INVITATION FOR BIDS

TOWN OF CHILMARK

**PROJECT: 2011-MLR-ROADS-II  
ADDENDUM # 2-Drip Edge, Peastone  
MIDDLE LINE ROAD COMMUNITY  
HOUSING PROGRAM  
FINISH ROADWORK**

**1 Peastone Drip Edge**  
L2.1 Not To Scale

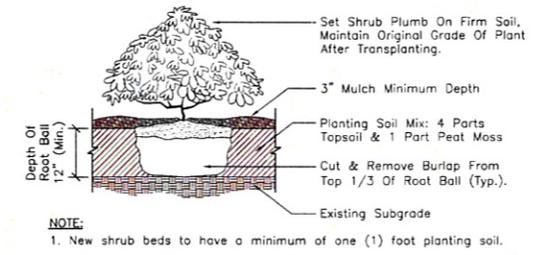
- 2.1 AGGREGATE SURFACING AT DRIVEWAY: ASTM C33 Standard Specification for Concrete Aggregates; crushed natural stone.
- A. Color: Brown to match Architect approved sample.
  - B. Size, Gradation: ASTM C33 Size Number 8.
- 2.2 AGGREGATE SURFACING AT DRIP STRIP: ASTM C33 Standard Specification for Concrete Aggregates.
- A. Color: Brown to match Architect approved sample.
  - B. Size, Gradation: Uniform 0.375 inch.
  - C. Shape, Appearance: Rounded, weathered, washed.
- 2.3 SUBBASE CRUSHED STONE: ASTM C33 Standard Specification for Concrete Aggregates.
- A. Size, Gradation: ASTM C33 Size Number 4 to 67.

- 3.1 INSTALLATION OF AGGREGATE SURFACING:
- A. Subgrade: Compact to at least 95 percent of maximum dry density, Method C, ASTM D1557 Standard Test Methods for Laboratory Compaction Characteristics of Soil Using Modified Effort.
  - B. Subbase Crushed Stone at Driveways: Provide minimum 9 inches compacted depth placed in two lifts.
    - 1. Compact each lift to at least 95 percent of maximum dry density, Method C, ASTM D1557 Standard Test Methods for Laboratory Compaction Characteristics of Soil Using Modified Effort.
  - C. Subbase Crushed Stone at Drip Strip: No subbase required.
  - D. Aggregate Surfacing:
    - 1. Provide minimum 4 inches compacted depth of aggregate surfacing.
    - 2. Control elevations and meet finished grades shown.
    - 3. Compact to at least 93 percent of maximum dry density, Method C, ASTM D1557 Standard Test
